Product Safety Recall

N202324251 Roof Rail Air Bag Inflator May Rupture

Release Date: July 2022

Revision: 04

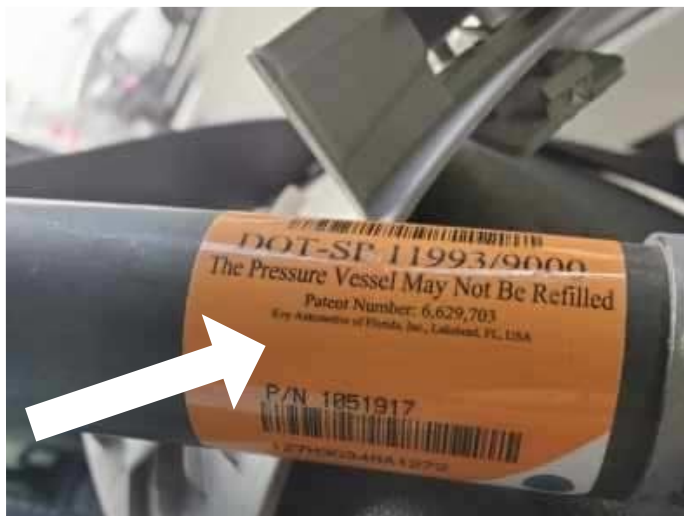
- Scan the VIN and scan new LH part (barcode or QR code) on the airbag and submit.
- Then, repeat - Scan the VIN again and scan new RH part (barcode or QR code) on the air bag and submit again.

Please center ONLY the QR Code within the Red Brackets as seen below. If the scan function is inaccurate, please use the guide below for entering the information manually into the RPT fields.

From the recall example photo above:

Part Number: 7503881C91

VPPS: 4770101000000R

DUNS: 74040

Traceability Number: 21221258RH006120

6058856

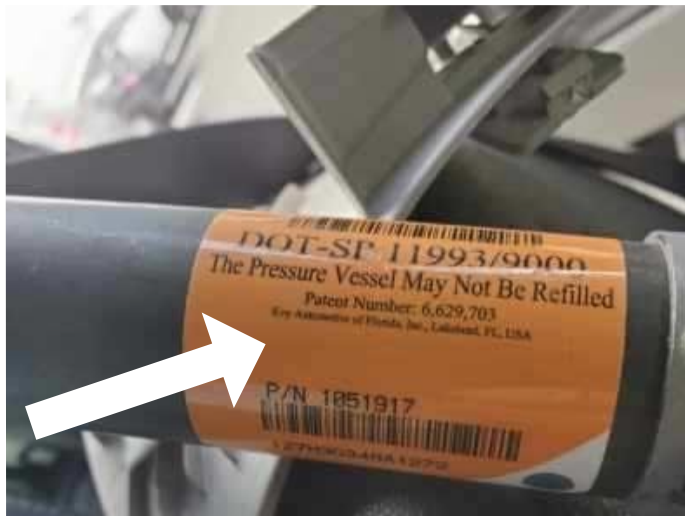
Record the serial number on each of the white airbag labels.

DO NOT record the serial number (orange label) on the inflator.
